BRITISH GLIDING ASSOCIATION

BGA TECHNICAL COMMITTEE

TECHNICAL NEWSHEET TNS 1/2/91

L' Adellier Connectors

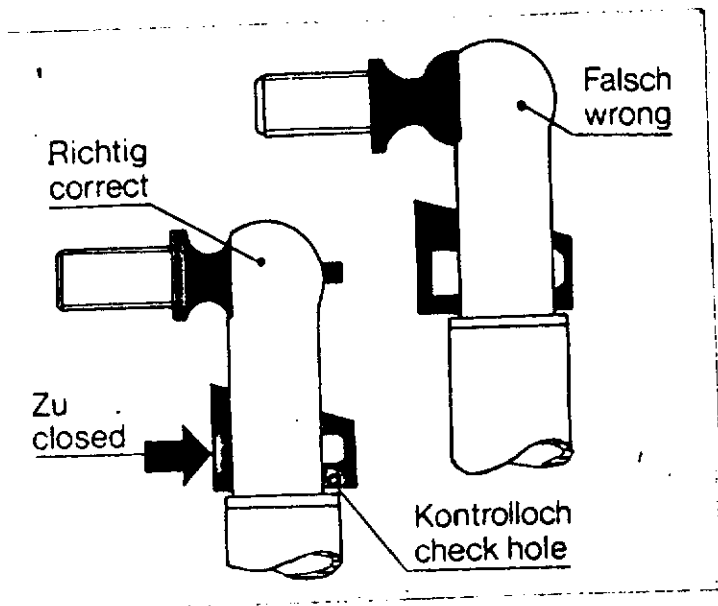
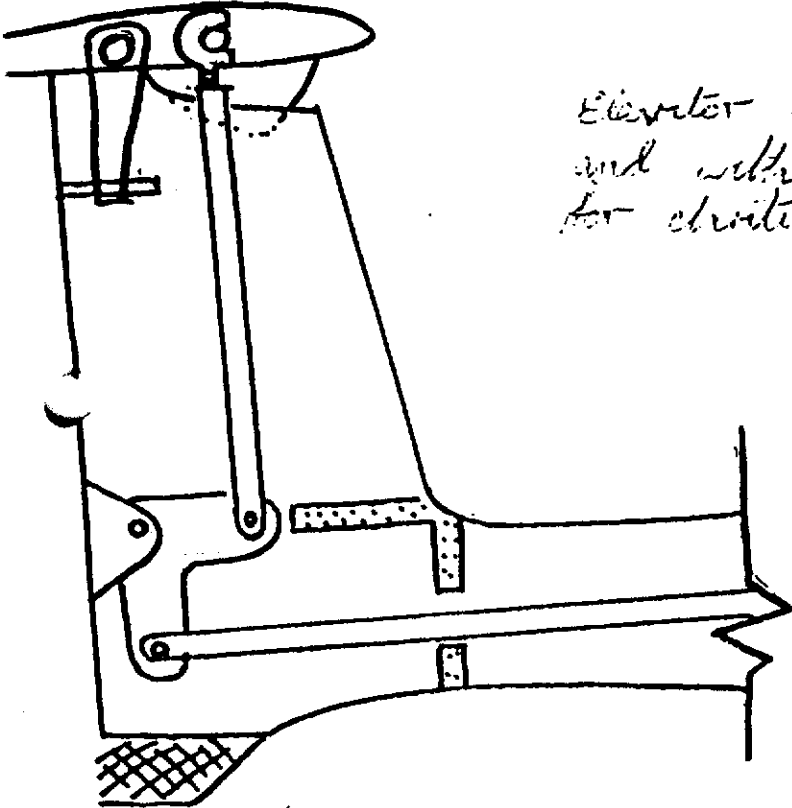
- 1.4 KA 6, 7, 8 Airbrake Push Rods (Bending) - Sketch from I.D. Smith, is self explanatory.
- 1.5 L'Hotellier Control Connectors - R.D. AVIATION have a supply of "Sticky" transfers as illustrated herewith, to remind you how to connect your controls correctly (Call 0865-841441 for details).

Why not plaster these
"Stickers" whenever you
have a connector?

BENT PUSHROD
TO ELEVATOR

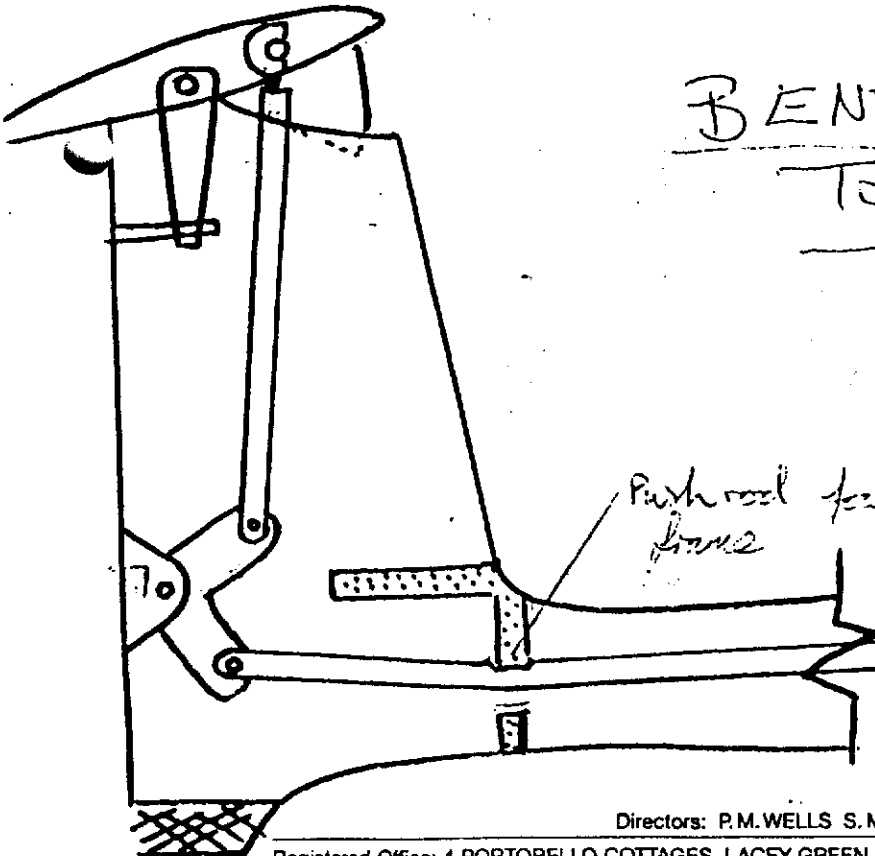
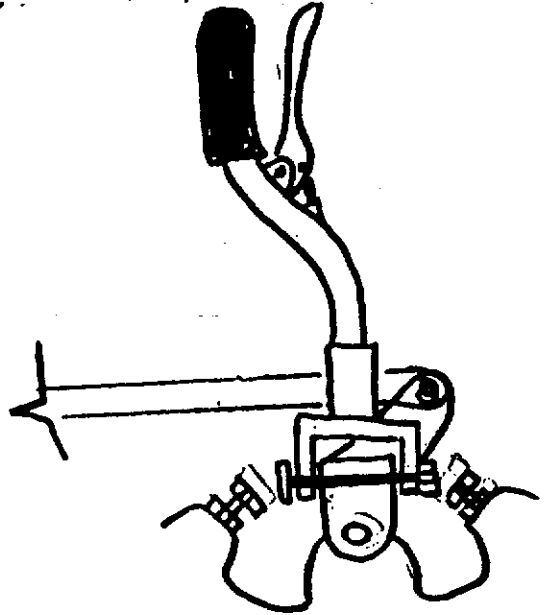
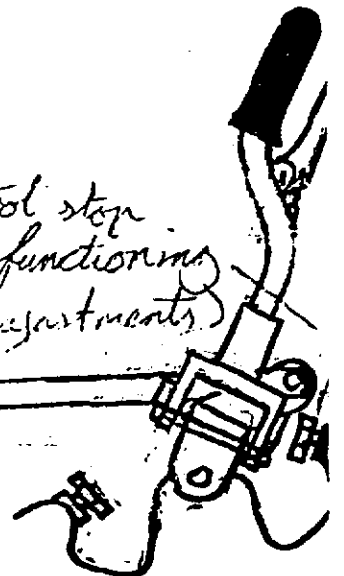
- 1.2 STD CIRRUS - Bent Elevator Push Rod fouls in frame at base of fin. (Reported by Peter Wells with diagram).
- 1.3 Bocian - Indications of "sloppy" airbrake operation on the ground, subsequently leading to failure in flight, caused by a fracture of the handgrip below the side of the front seat. (Reported by Coventry G.C.).

Elevator circuit not to any scale and with partly simplified stick arrangement for clarity

control stop not functioning (out of adjustment)

TAILSKID FIXING K13.

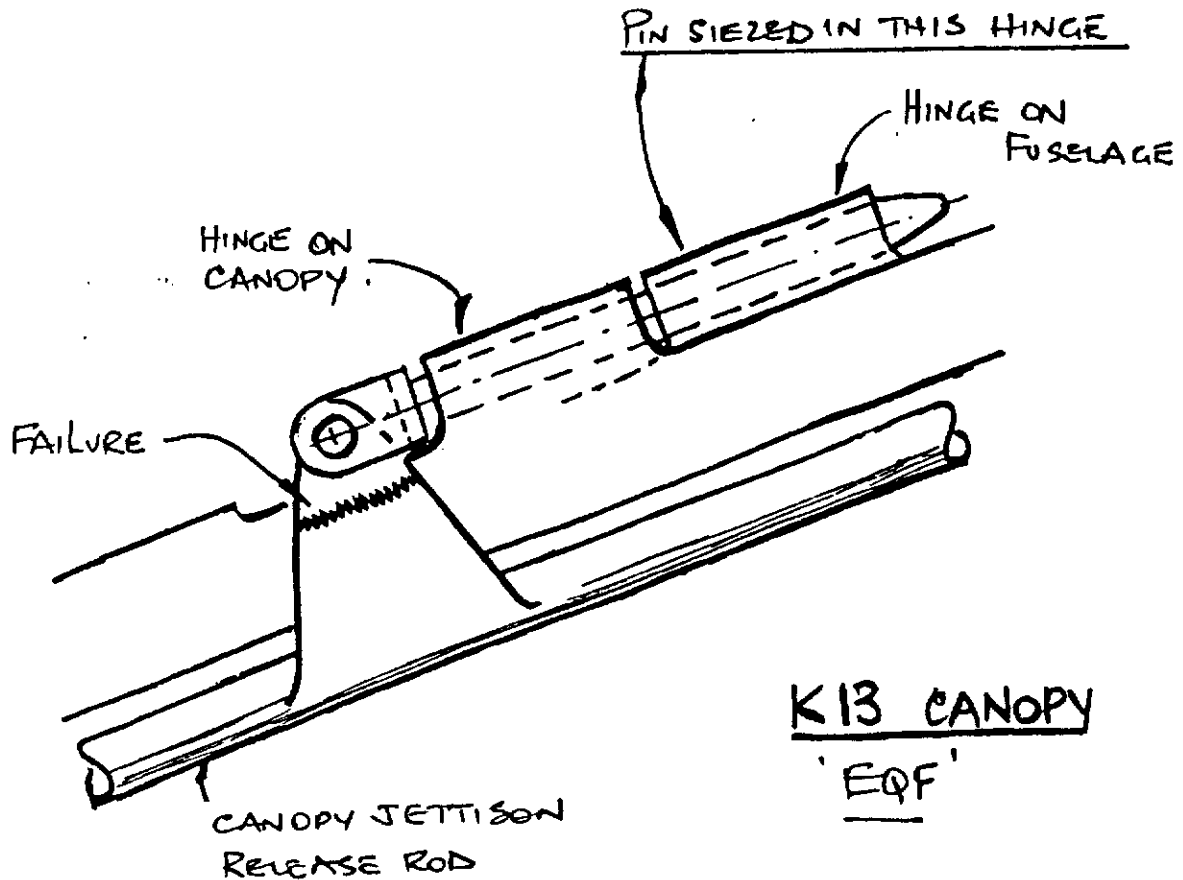
A. K13 "DMX"

WHILST ON LOAN TO ESSEX & SUFFOLK CLUB THIS GLIDER SUFFERED A FAILURE OF THE TUBES AT THE TAILSKID FRONT BOLT ON LANDING : AS PER SKETCH.

INSPECTION OF FAILURE SHOWED THIS TO BE FATIGUE PROBABLY INITIATED BY A HEAVY IMPACT OF THE TAIL SKID SOMETIME PREVIOUSLY - WHICH HAD NOT BEEN REPORTED. IT WAS NOTICED, ON STRIP DOWN, THAT THE TAILSKID FRONT BOLT HAD BEEN TIGHTENED SUCH THAT IT WOULD NOT ARTICULATE AS RUBBER DEFLECTED.

THIS WOULD INDUCE EXCESSIVE BENDING LOADS IN BOLT & ACCELERATE FAILURE.

B. K13. "EQF"

SINCE THE ABOVE FAILURE PARTICULAR ATTENTION HAS BEEN PAID TO THIS AREA BUT 2ND "FAILURE" WAS ONLY NOTICED WITH GLIDER ON LAUNCH LINE IDENTIFIED BY BUCKLING OF FUSELAGE FABRIC. THIS GLIDER HAD HAD A BROKEN BOLT SOME TIME PREVIOUSLY. THERE WAS NO EVIDENCE OF TUBE DISTORTION AT THE TIME TH. BOLT WAS DRILLED OUT.

1. GROUND HANDLING

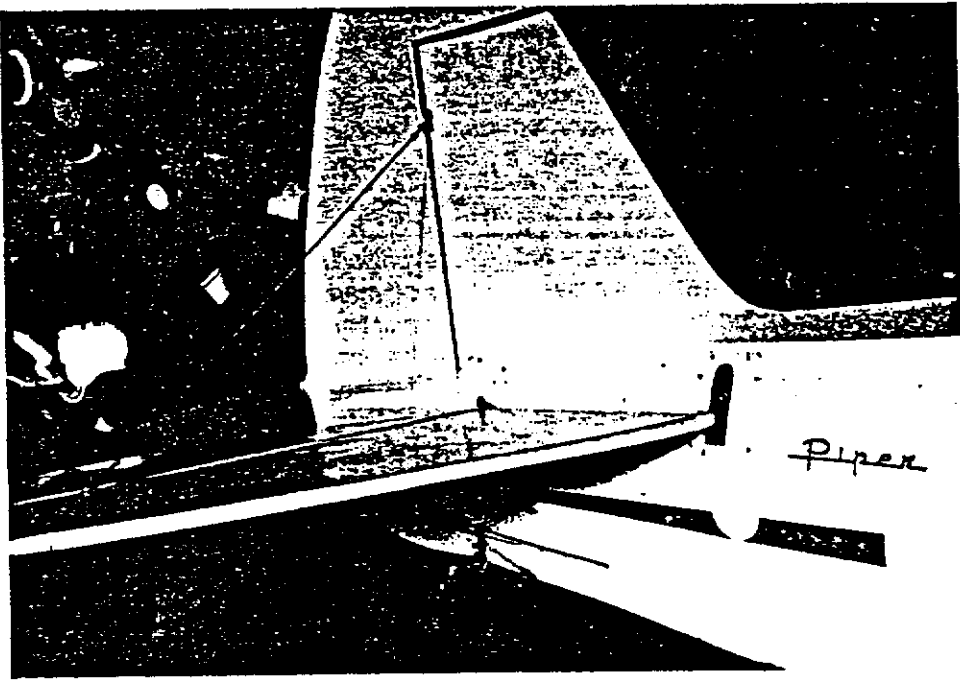
A Piper Pawnee 150 suffered an inflight tailplane attachment failure. Fortunately, the pilot managed to land the aircraft safely, although the landing was somewhat heavy.

The failure was caused by the fracture of the attachment tube to which the front spar of the right tailplane was attached. An Alert Airworthiness Directive was subsequently sent to all Piper Pawnee operators and the responses indicated that, although there had been no other incidents of front spar attachment failure, there had been a number of cracked rear spar attachments. The Airworthiness Directive was revised to include both spar attachments and to include repetitive inspection.

However, discussions with operators revealed that Piper Pawnee aircraft are often moved by lifting the tailplane prior to wheeling the aircraft and, because the 150 h.p. variant is only wire braced at the rear spar, (unlike the 235 and 265 versions which are wire braced at both spars), very high stresses can

be induced in the attachment tubes. Stress calculations have been carried out for maximum weight at maximum aft centre of gravity and, assuming two people are lifting by grasping the tailplane leading edge at points well away from the fuselage side the result is very high bending stresses which are thought to be the main contributory factor to

the original failure.

It is recommended that, if Piper Pawnee aircraft are moved by lifting the rear end, the tailplane is grasped at points immediately adjacent to the fuselage. The same advice also applies to Piper PA18 and PA22 aircraft which also have wire bracing only on the rear spar

FIGURE A

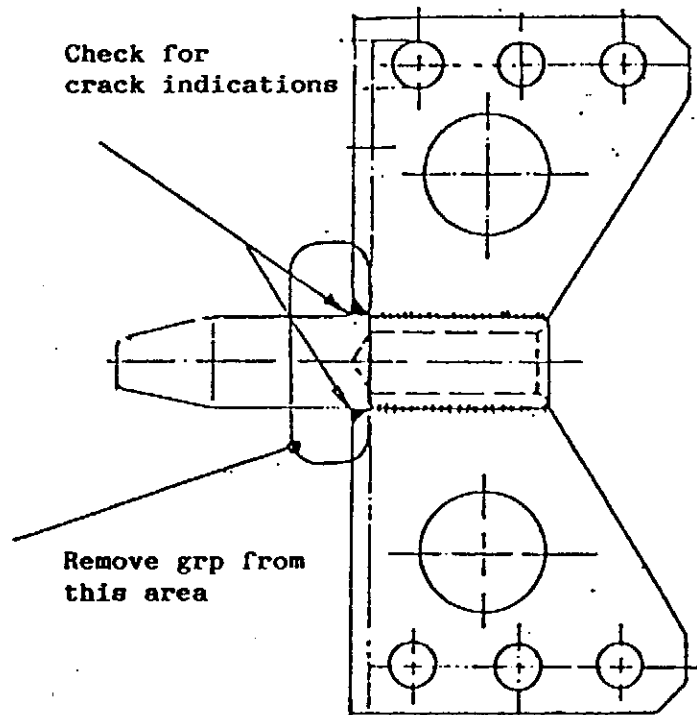
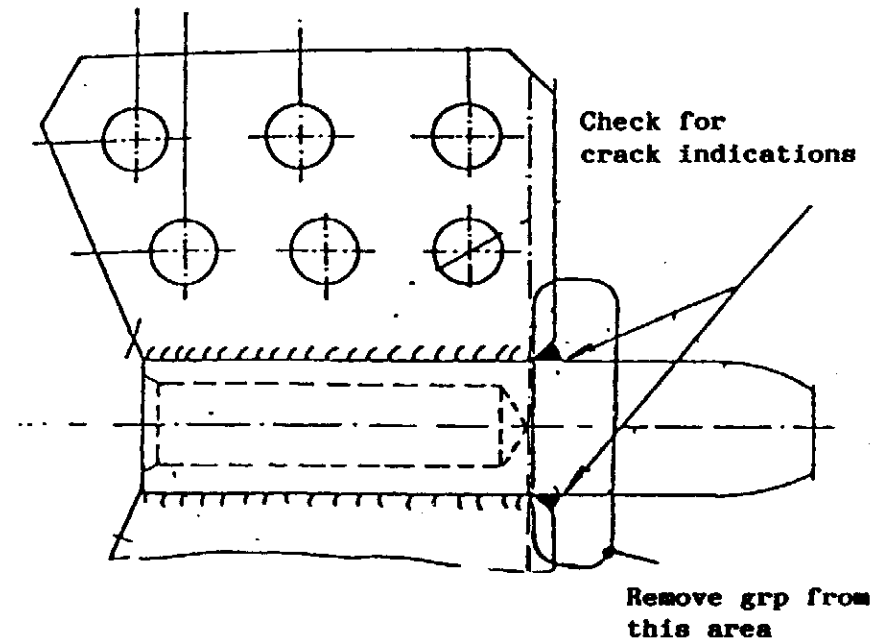
- (iii) Inspect the end of the weld and the spigot itself at the toe of the weld for cracks, using a x10 magnifying glass (four places) - see Figure A. There are two spigots per aircraft and cracks can occur on the top and on the bottom of the spigot.

- (iv) If a crack is suspected, and appears to be confined to the weld itself, ie does not extend circumferentially into the spigot, or where there is a lack of weld penetration, the wings may be replaced. The aircraft may be flown to a place where the existence of cracks can be confirmed or otherwise by NDT means, by an Organisation approved for that purpose by the CAA. The flight must be conducted with the pilot only on board. Abrupt manoeuvres and/or high speeds are prohibited. If a crack is confirmed either in the weld only or in the spigot itself, rectification must be carried out to the manufacturer's approved repair scheme before further flight.
Report the results of the inspections to the manufacturer and to the SDAU of the CAA.

<u>CAA AD No</u>	<u>Associated Material</u>	<u>Description</u>	<u>Applicability - Compliance - Requirement</u>
006-10-88 (continued)			(v) Where the spitots are found to be not cracked either after the actions of (iii) or (iv) above, reprotect the area where the grp has been removed, either with a lacquer or a brushed coat of epoxy resin. Replace the wings to the instructions in the Flight Manual. Repeat the instructions commencing at (i) above except that only the re-protection has now to be removed, at intervals not exceeding 300 hours.
